Reference: GC Estates Addition, Preliminary Plan

We have revised the Preliminary Plan as per your comments dated 6-27-2022. Our responses are below

Preliminary Development Plan Review

(GC Estates Addition)

OVERALL EXISTING DRAINAGE
 PRELIMINARY PLAN
 GC ESTATES ADDITION

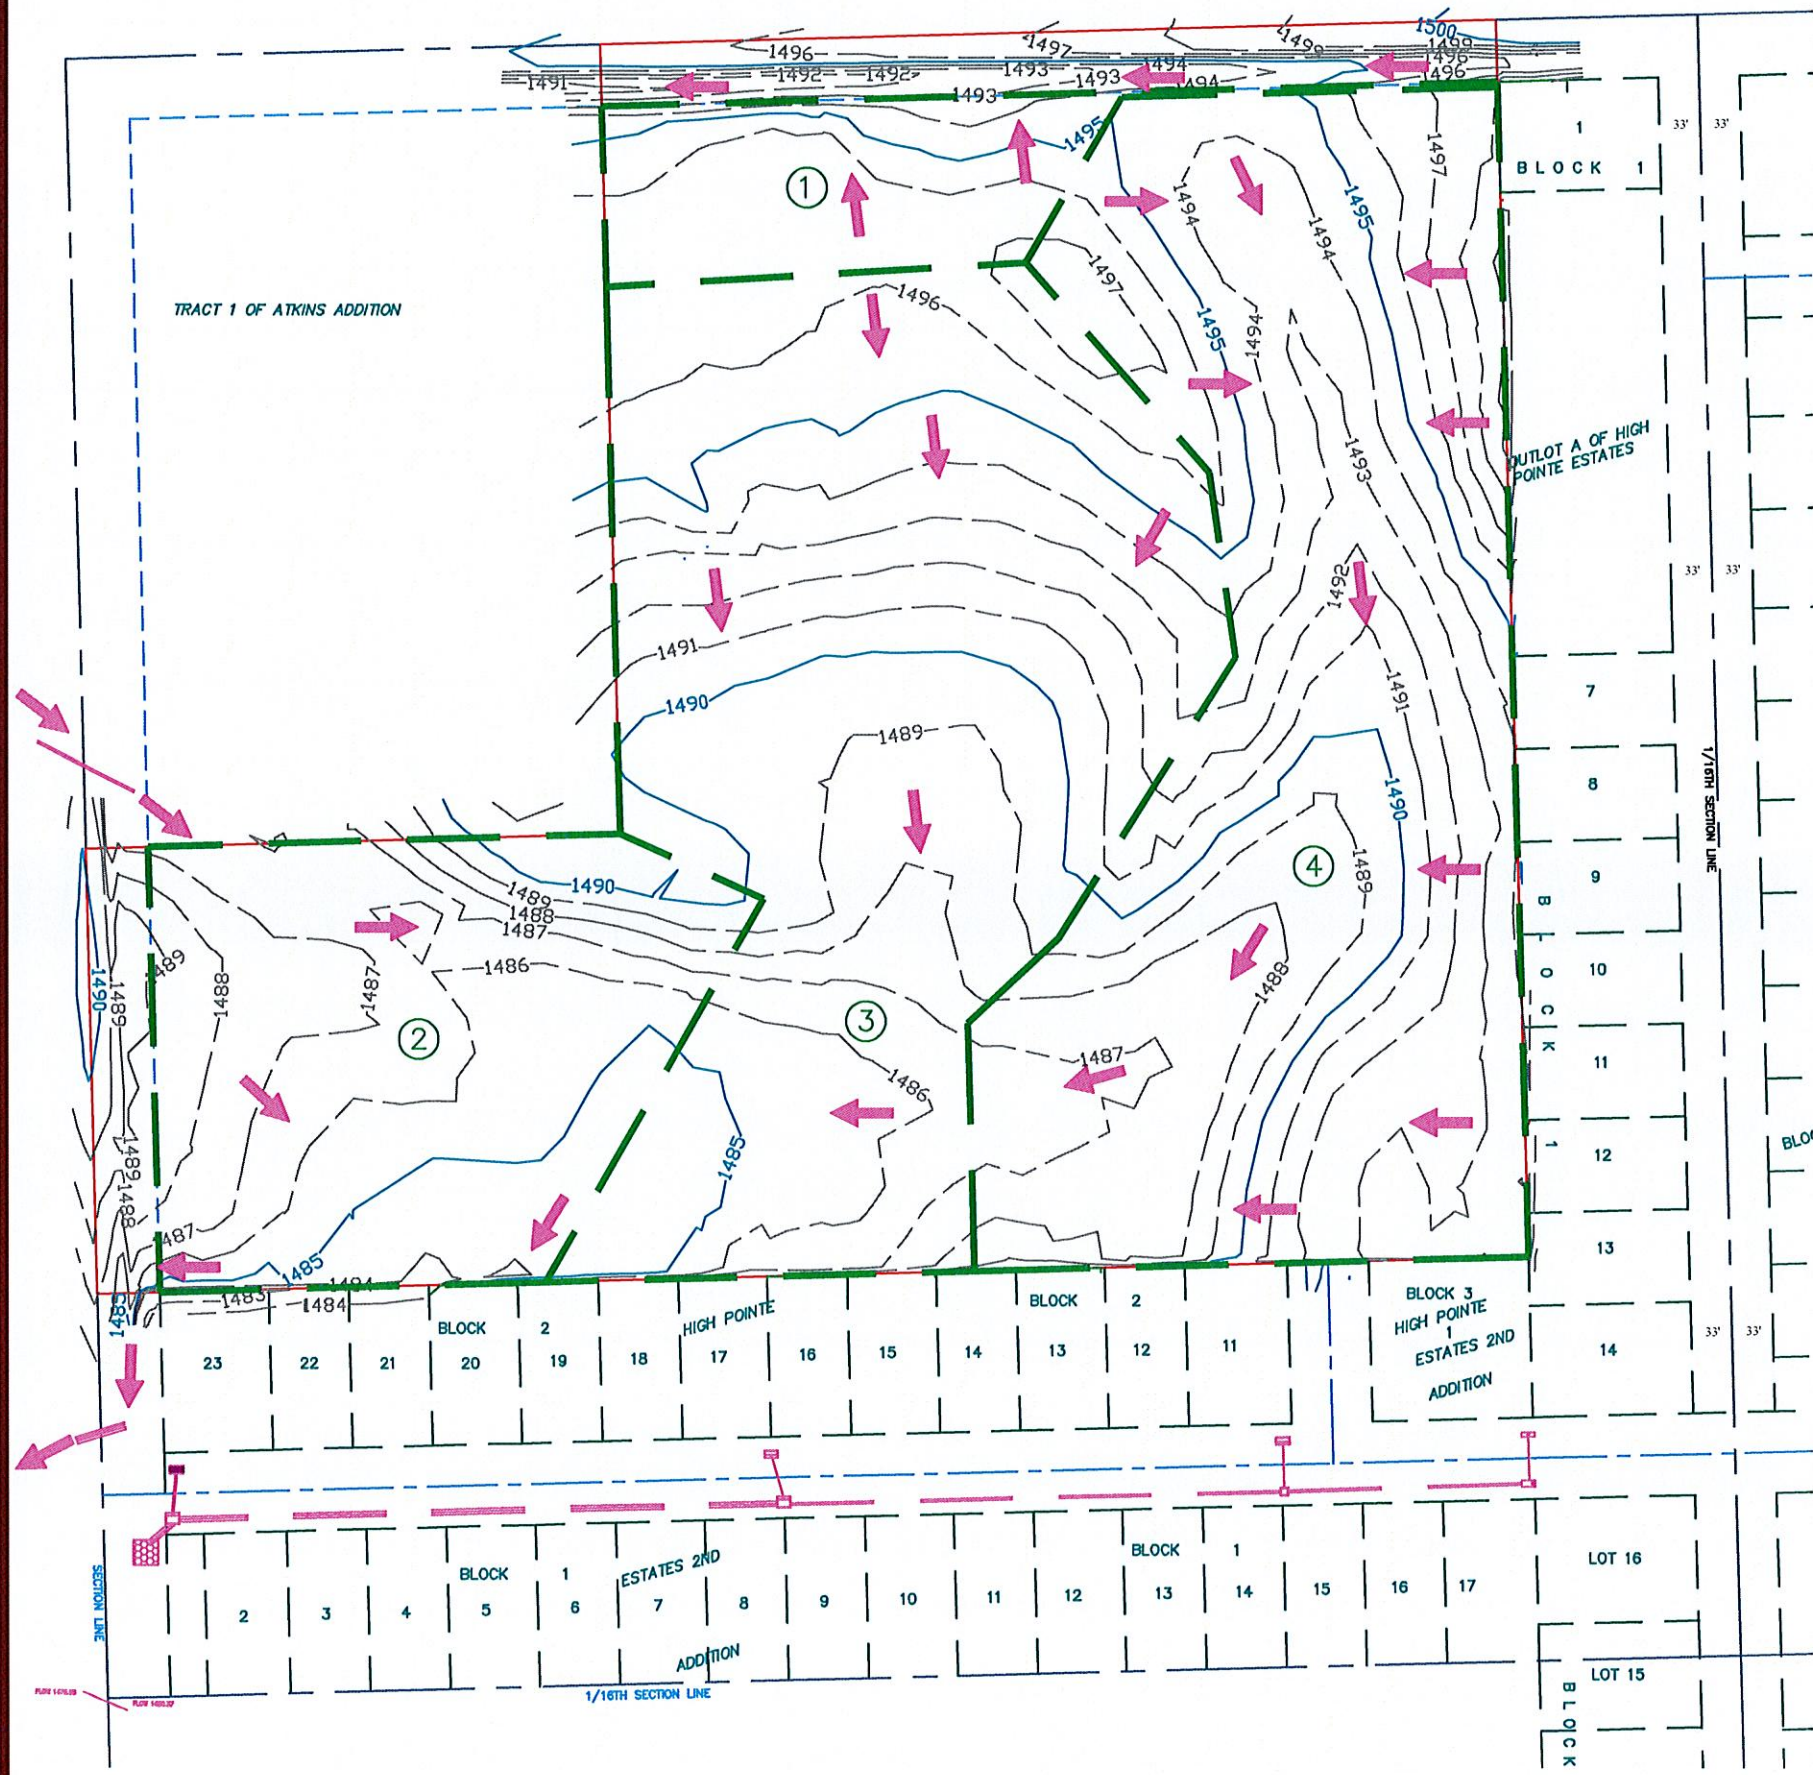
12. Please show flow arrows on the Existing Drainage Plan sheet to illustrate pre-development flow directions. - **Added**

13. Please identify locations on the Existing Drainage Plan where runoff enters this subdivision from outside areas and any discharge points where runoff within the subdivision leaves the area. The channel that cuts through the southwest portion of the subdivision isn't defined at all with your contours...this channel must be defined in these plans – you may need to collect more survey to properly define this. – **Added Moving the pipe to the back of the lot to allow the flow to bypass the detention pond and flow back into the ditch**

14. Please include another sheet that illustrates the extents of other drainage basins that contribute to flows entering/passing through this subdivision area – you will need to account for this flow with the subdivision's drainage system – this especially pertains to the flow coming from the west under/over 468th Ave. That basin is QUITE Large...**Added.**

PROPOSED DRAINAGE
 PRELIMINARY PLAN
 GC ESTATES ADDITION

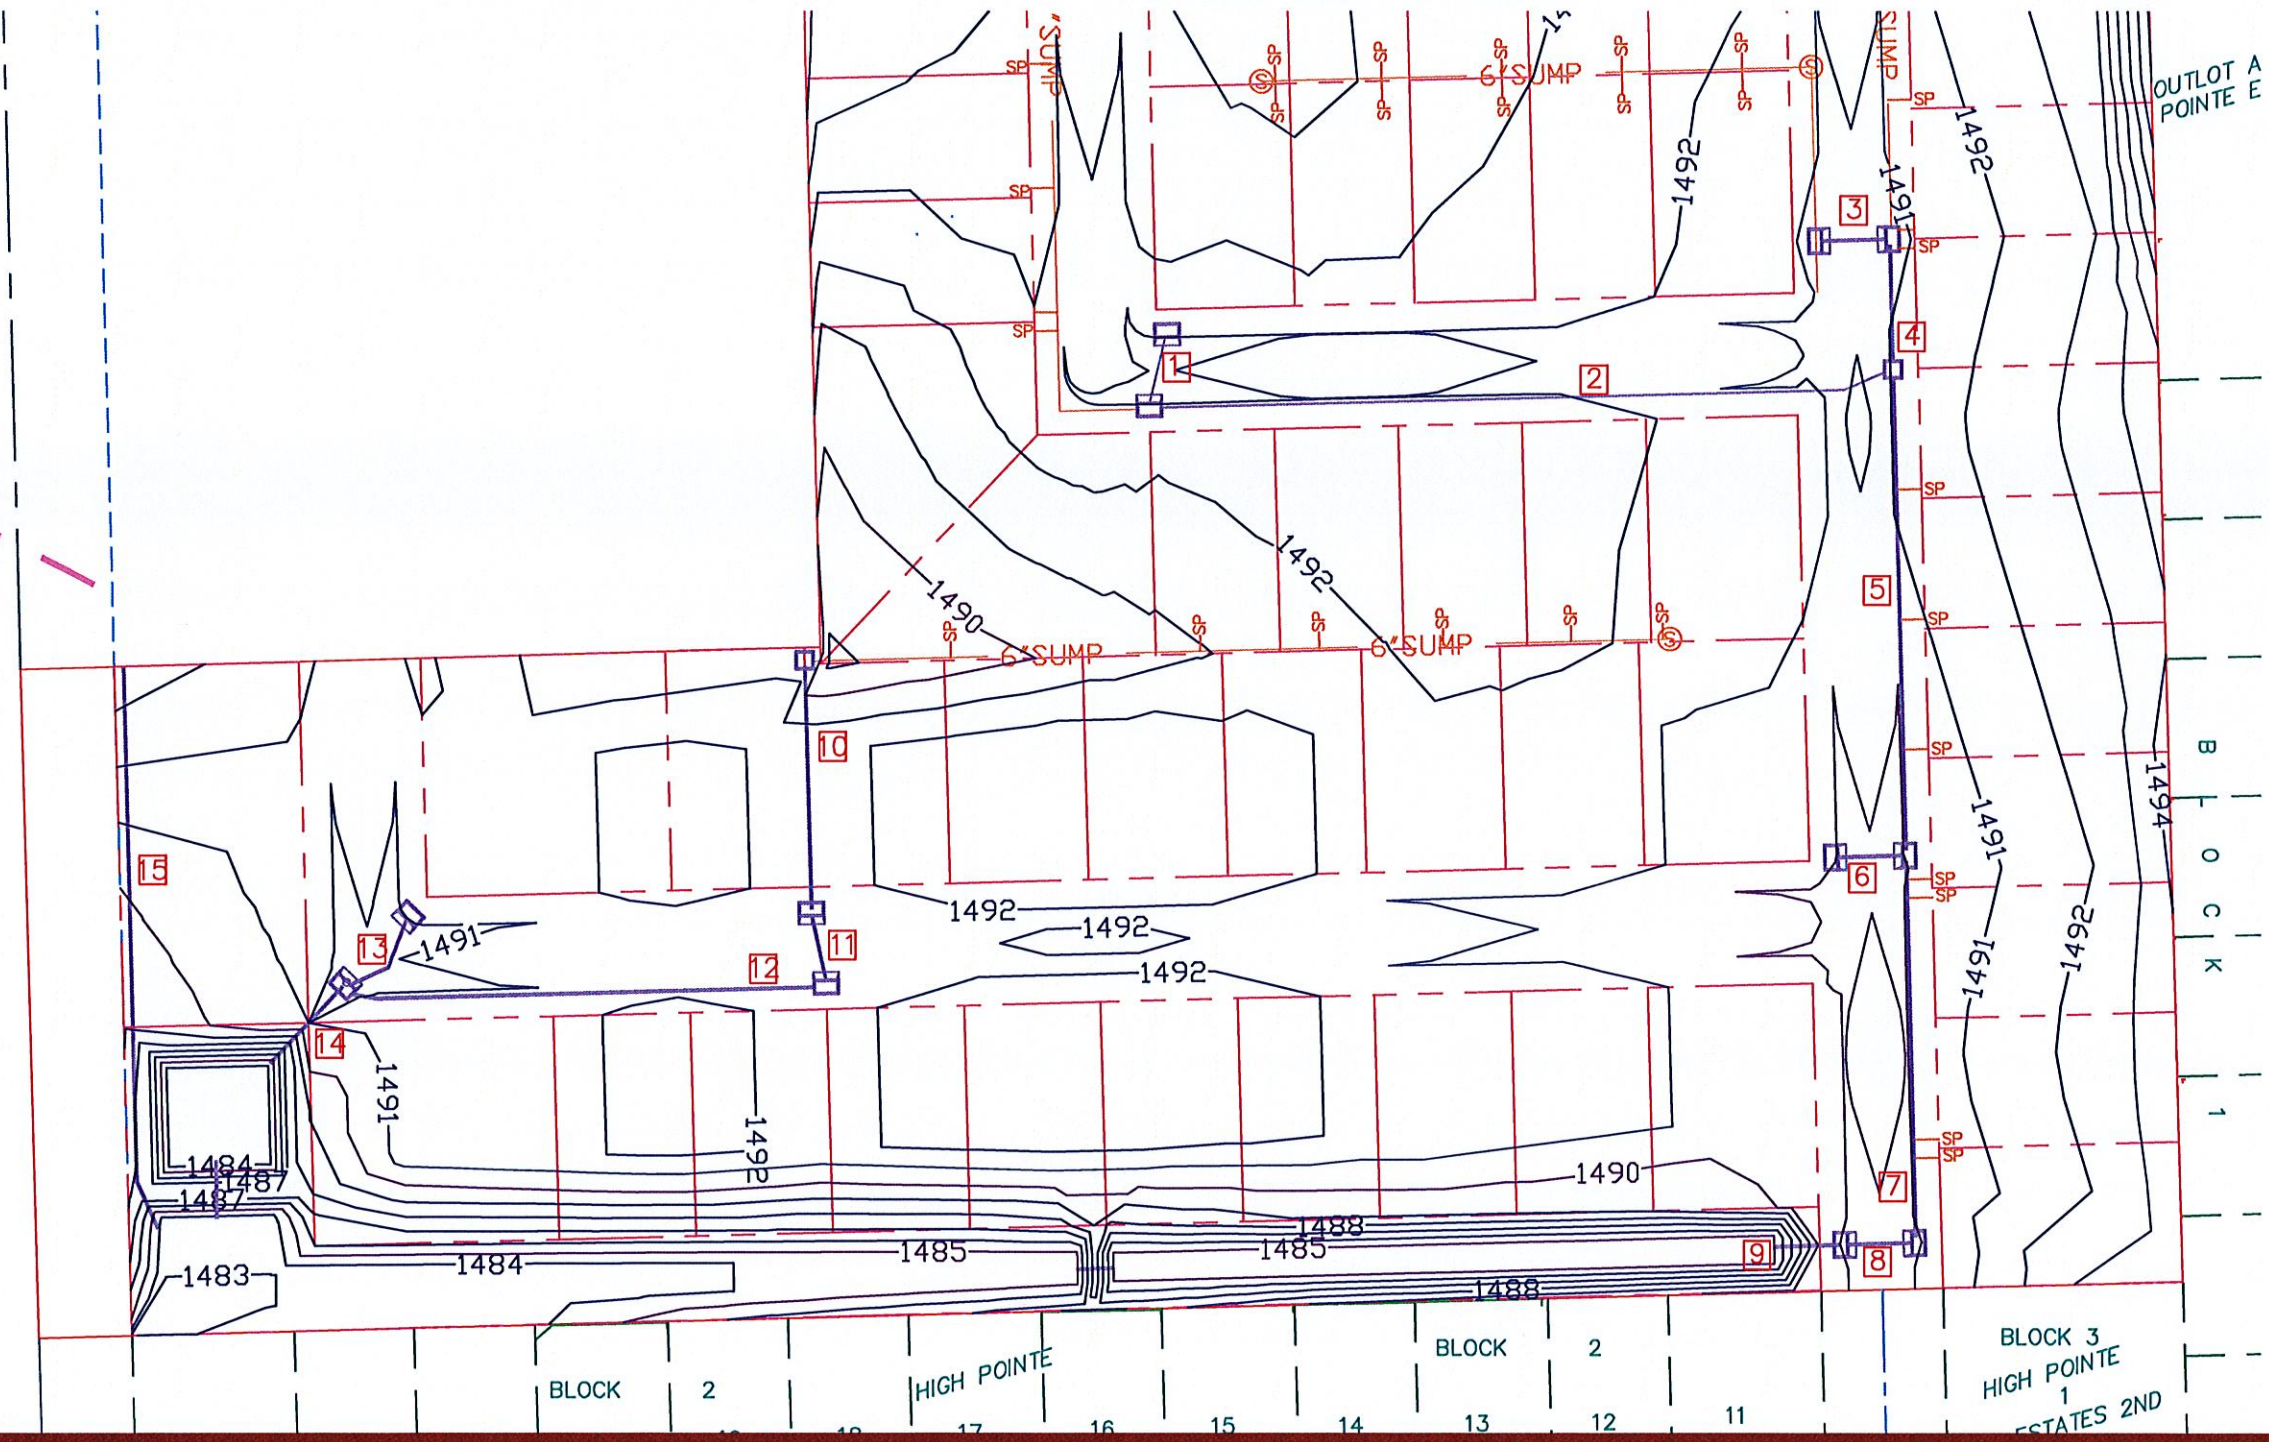
15. The storm sewer pipe illustrated to go along the south side of "Taylor Street" appears to end in a small structure or a blind manhole at the east side of the Titan Ave intersection – we will not allow a blind pipe connection – there must be a surface structure there to access for maintenance. – **That is intended to be a Junction Box. The size of the symbol was increased on the plans.**

22. Per note 15 on Sheet 6 regarding the size of pipe for the conveyance of flow from 468th Avenue, this pipe must be sized with the DEP assuming rerouting of flow from the WPA is not accommodated outside of this subdivision (the city has been informed by the US GF&P that they will not entertain modifications to this flow on their property until there are plans for the urbanization of 468th Avenue). – **The Pipe will be sized in the DEPs**

WEST DETENTION POND

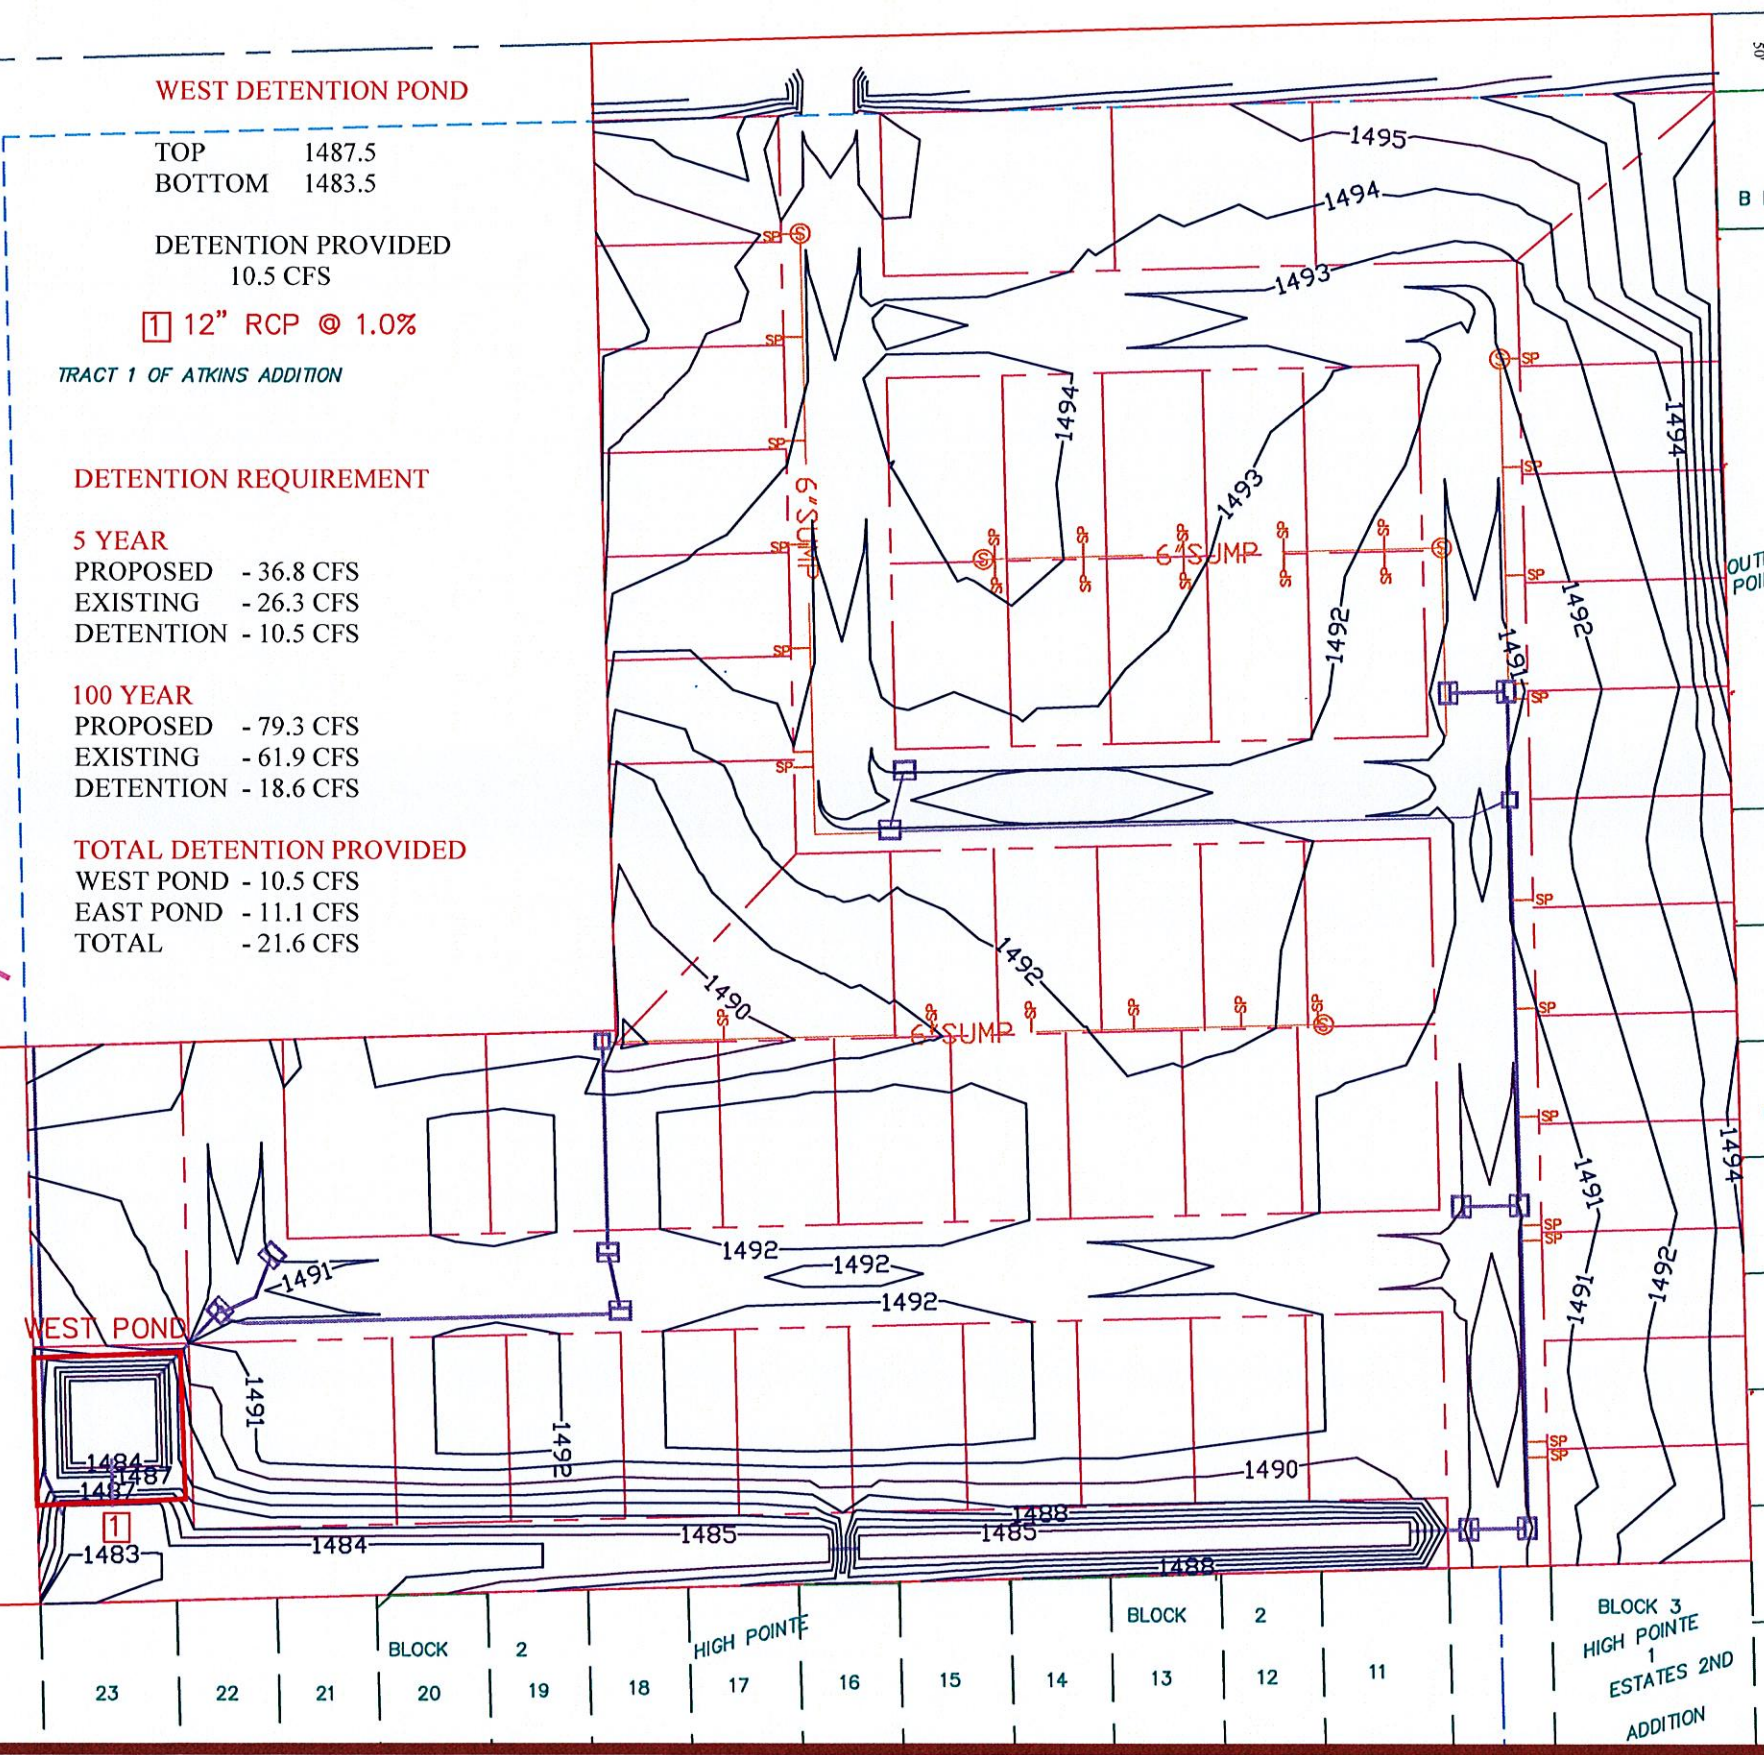
8. Choose a different name for "W. Taylor Street" as there is already a "Taylor Drive" in town and thought these two were too similar. - **Revised to W. Benjamin Street**

9. The slope of the linear detention pond that makes up Lot 12 in Block 1... appears to be pretty flat, which is OK, but we'll require the bottom to be paved with concrete if the bottom has a slope of 0.50% or less...which it looks to me like it's right at or below that limit...I would also advise that the concrete pavement at the bottom of that channel/pond is 6-feet wide and includes a curb along the edges to confine the "low/trickle flow" in the paved area while larger flows can temporarily rise up the inslopes along the banks of the channel - we are doing this in another drainage channel in town to manage wetland vegetation. - **The detention ponds are proposed to have flat bottoms and the developer wishes to have a natural bottom in the ponds. For the portion of the drainage area that is a channel we are proposing a slope of greater than 0.50%. Final slope to be determined and included on the DEPs.**

20. Sheet 7 has "east detention pond" in the top left of the sheet, it should be "west detention pond" – **Revised**
21. If the conveyance of the outside drainage basin from 468th Avenue that is captured and conveyed by the storm sewer pipe at the west end of W. Matthew Trail is discharged into the west pond, it is highly probable the outfall structure and pipe in the west pond (the 12" RCP @ 1.0% slope) will be substantially overwhelmed with this flow. – **The proposed pipe is moved to the back yard adjacent to the road ditch so the flow will bypass the detention pond.**
